NAME	DATE	TITLE: Overall View			
DRAWN	PMG	1/22/2020				
CHECKED						
ENG APPR.						
MFG APPR.						
Q.A.			SIZE DWG. NO. REV B 2 ?			
COMMENTS:						
DO NOT SCALE DRAWING			SCALE: 1:20		WEIGHT:	SHEET 2 OF 31

NAME	DATE	TITLE: Dado		
DRAWN	PMG	1/22/2020			
CHECKED	RR	2/2/2020			
ENG APPR.					
MFG APPR.	RR	6/8/2020			
Q.A.			SIZE B		
COMMENTS:					
DO NOT SCALE DRAWING			DWG. NO. 4		REV A
			SCALE: 1:5		WEIGHT:

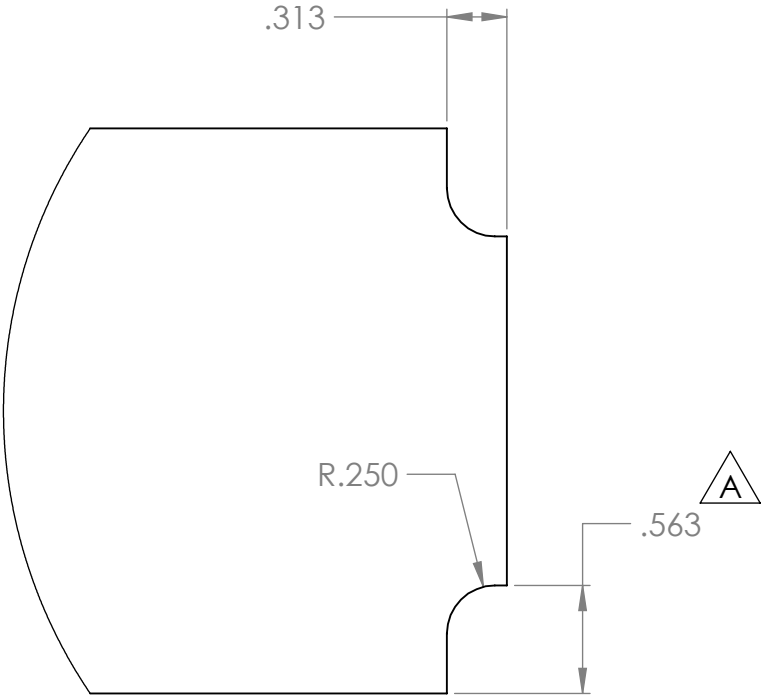
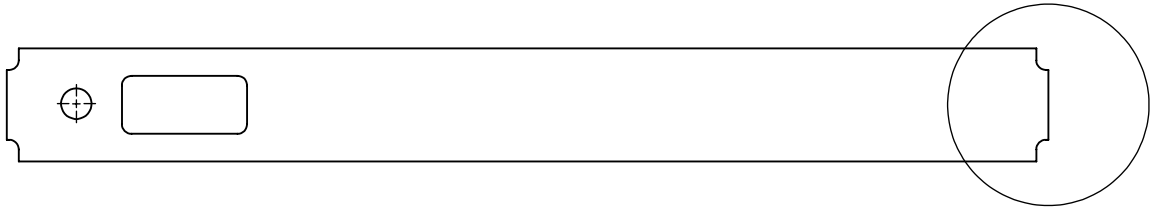
REVISIONS				
ZONE	REV.	DESCRIPTION	DATE	APPROVED
B1	A	Changed Dado Height from .75 to .5625 as it was too Loose in Production	11/3/2020	PG

NAME	DATE	TITLE: Left Side		
DRAWN	PMG	1/22/2020			
CHECKED	RR	2/2/2020			
ENG APPR.					
MFG APPR.	RR	6/8/2020			
Q.A.	PMG	10/7/2020	SIZE DWG. NO. REV B5A		
COMMENTS:					
DO NOT SCALE DRAWING			SCALE: 1:20 WEIGHT: SHEET 5 OF 31

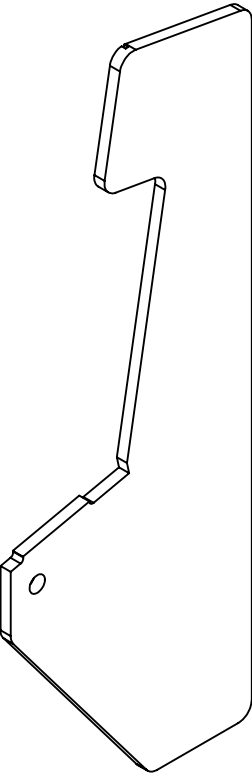
REVISIONS				
ZONE	REV.	DESCRIPTION	DATE	APPROVED
A4, B4	A	Added Button Hole and Extended Marquee Slot to top of Part	2/13/2020	PG
B4	B	ADDED NO T-MOLD CUT NOTE	2/6/2026	PG

NO T-MOLD CUT

NAME	DATE	TITLE: LED Panel		
DRAWN	PMG	1/22/2020			
CHECKED	RR	2/2/2020			
ENG APPR.					
MFG APPR.	RR	6/8/2020			
Q.A.	10/7/2020	10/7/2020	SIZE B		
COMMENTS:					
DO NOT SCALE DRAWING			DWG. NO. 8		REV A
			SCALE: 1:5		WEIGHT:

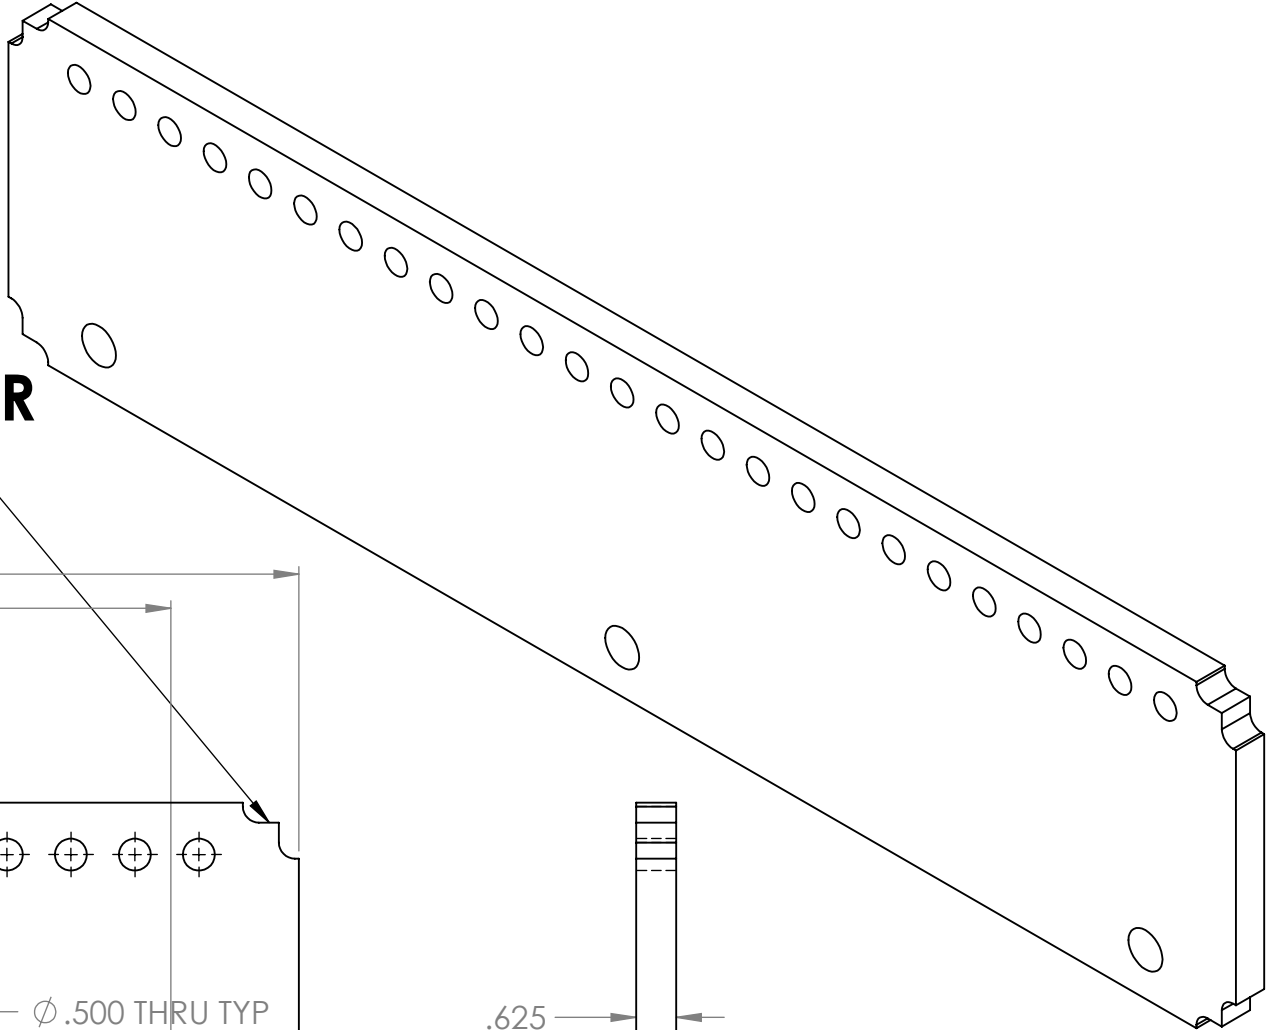
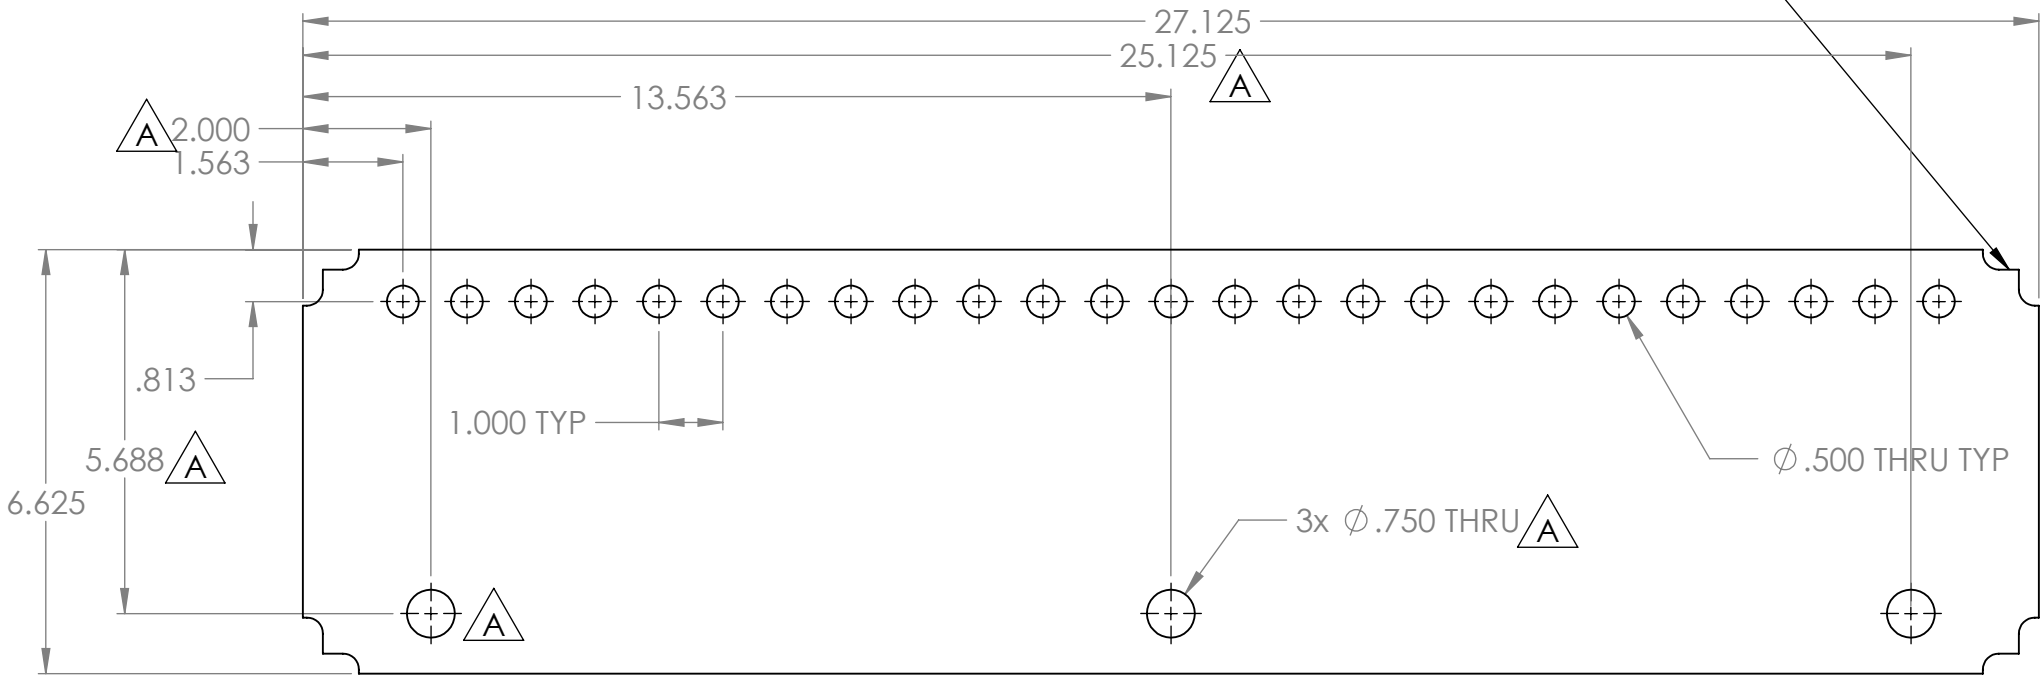
ZONE	REV.	DESCRIPTION	DATE	APPROVED
A2, A4, B3, B4	A	Changed Hole Diameter from .5 to .75, Changed the Location of all Holes Vertically and the Right Hole Horizontally, Added 3rd Hole on the Left Side	11/3/2020	PG

NAME	DATE	TITLE: Front Panel		
DRAWN	PMG	1/22/2020			
CHECKED	RR	2/2/2020			
ENG APPR.					
MFG APPR.	RR	6/8/2020			
Q.A.	PMG	10/7/2020			
COMMENTS:			SIZE B	DWG. NO. 9	REV ?
DO NOT SCALE DRAWING			SCALE: 1:5	WEIGHT:	SHEET 9 OF 31

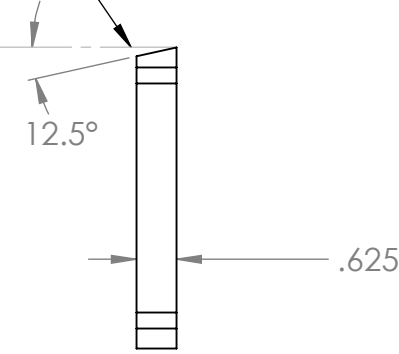
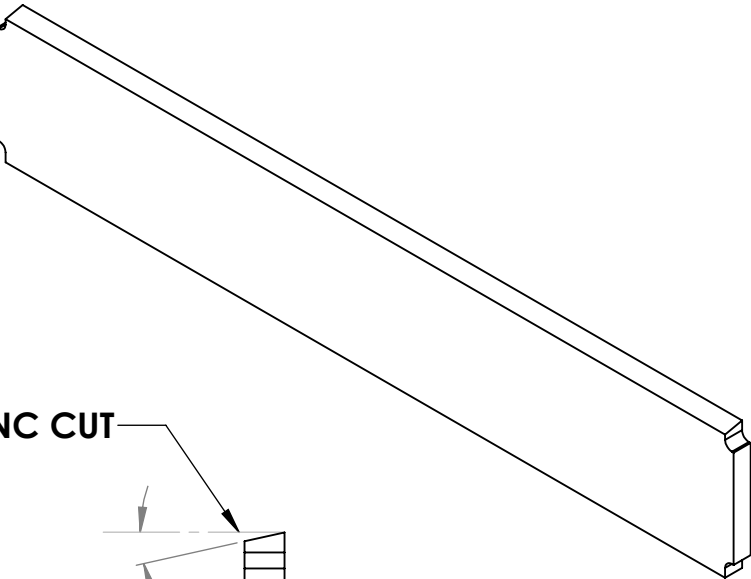
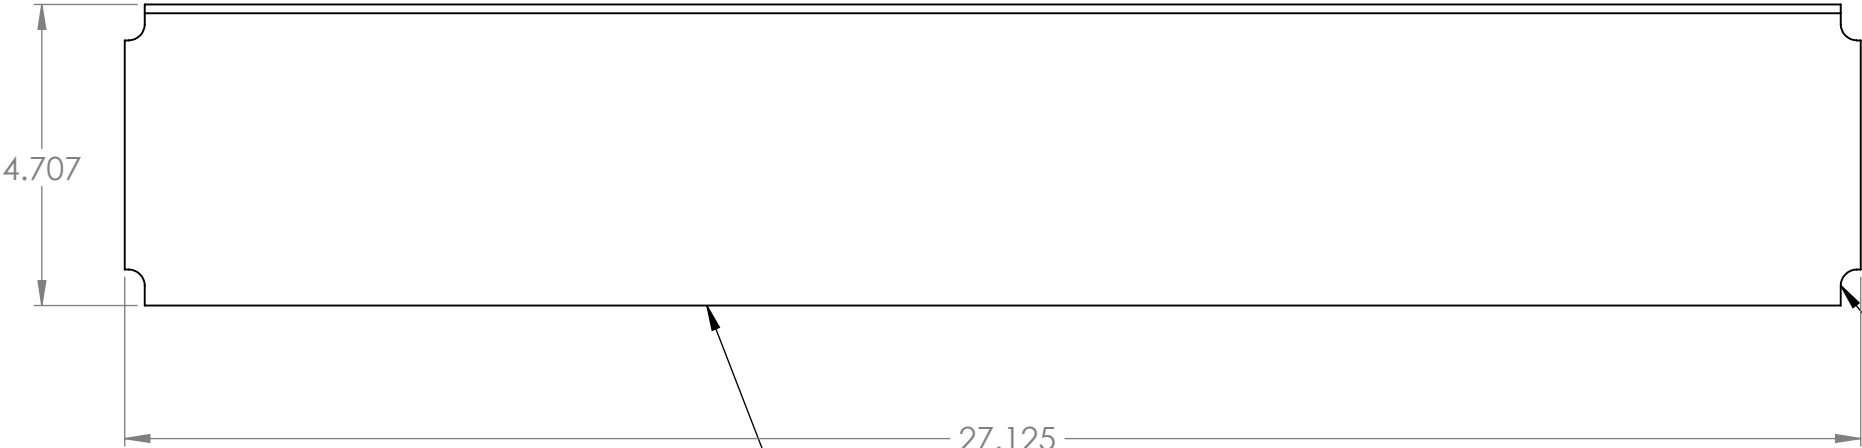
REVISIONS				
ZONE	REV.	DESCRIPTION	DATE	APPROVED
B1	A	Added Depth Dimension to rabbit on bottom	10/8/2020	PG
B2	B	Changed Diameter from .5 to .75	11/3/2020	PG

NAME	DATE	TITLE: Top Panel		
DRAWN	PMG	1/22/2020			
CHECKED	RR	2/2/2020			
ENG APPR.					
MFG APPR.	RR	6/8/2020			
Q.A.	PMG	10/7/2020			
COMMENTS:			SIZE	DWG. NO.	REV
			B	13	A
DO NOT SCALE DRAWING			SCALE: 1:5		WEIGHT:
					SHEET 13 OF 31

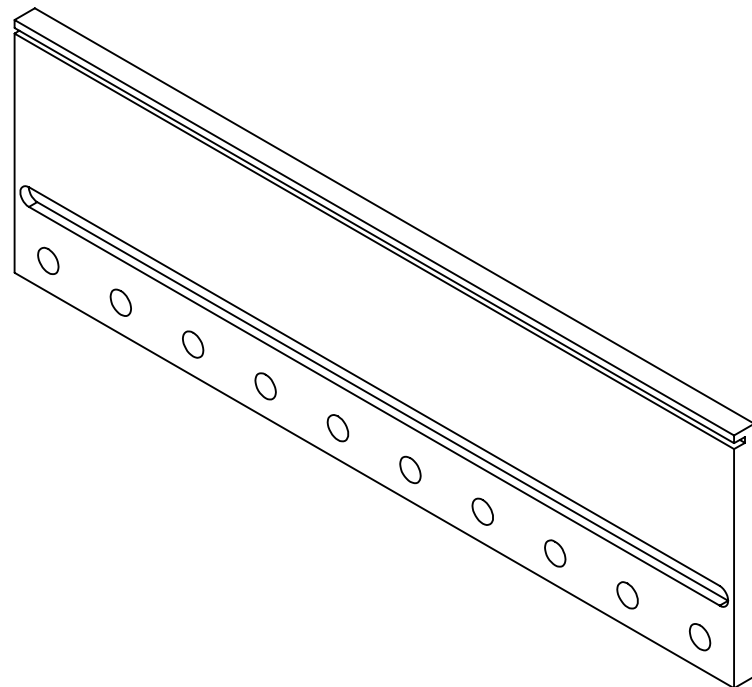
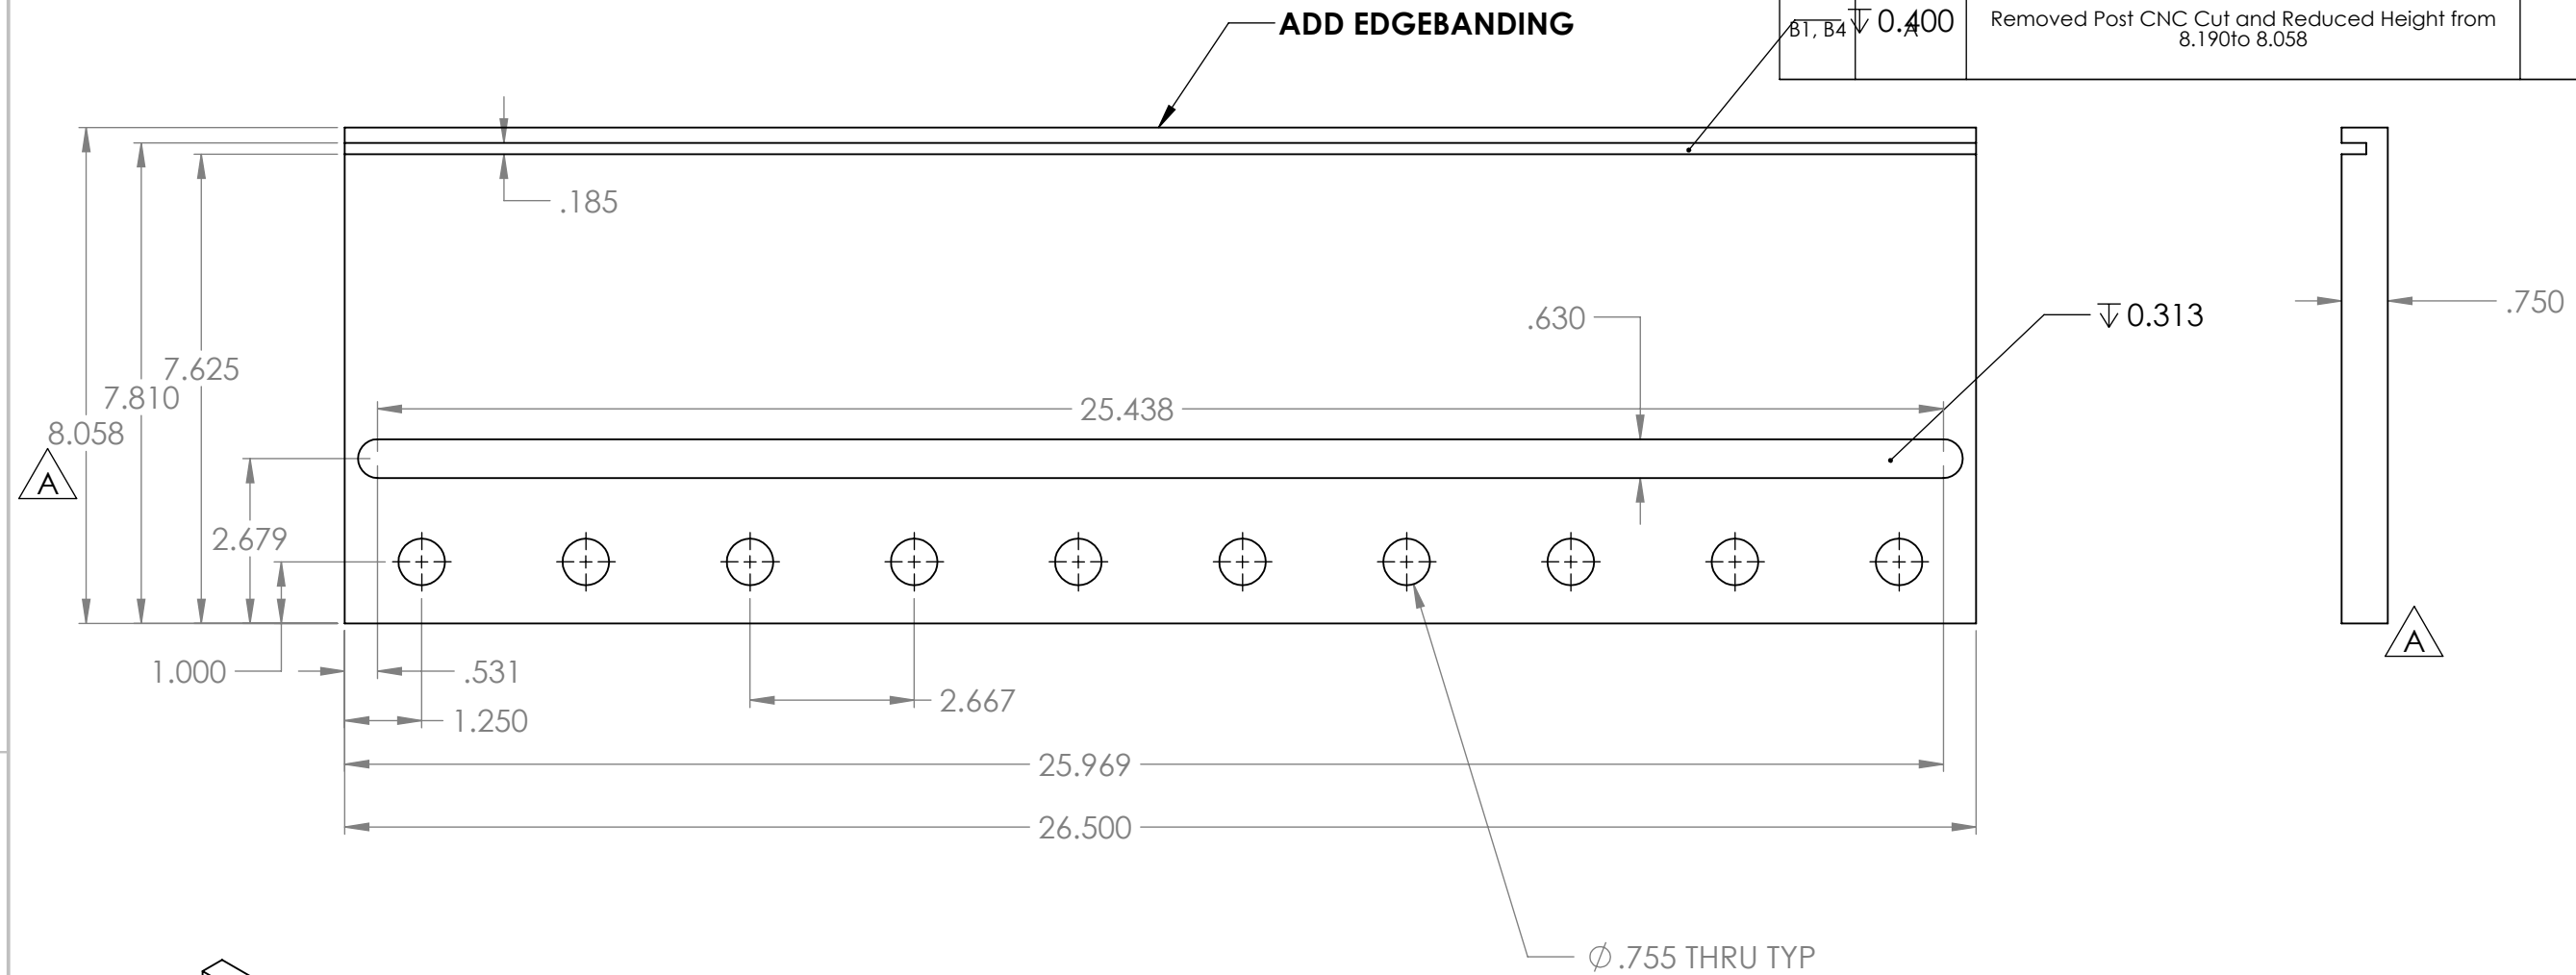
REVISIONS				
ZONE	REV.	DESCRIPTION	DATE	APPROVED
B1, B4	0.400	Removed Post CNC Cut and Reduced Height from 8.190 to 8.058	11/3/2020	PG
